FREDERICK COUNTY PLANNING COMMISSION September 12, 2012

TITLE: Manorwood Residential Cluster, Lots 95-

107.

FILE NUMBER: S-919B, AP 12427 (APFO 12428)

Existing Site Characteristics

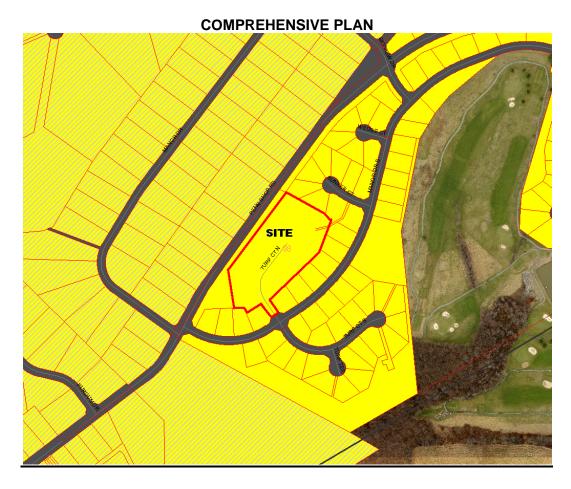
The 4.47 acre site is unforested open ground. The site is surrounded by residential lots that were approved and recorded per the 1994 preliminary plan.
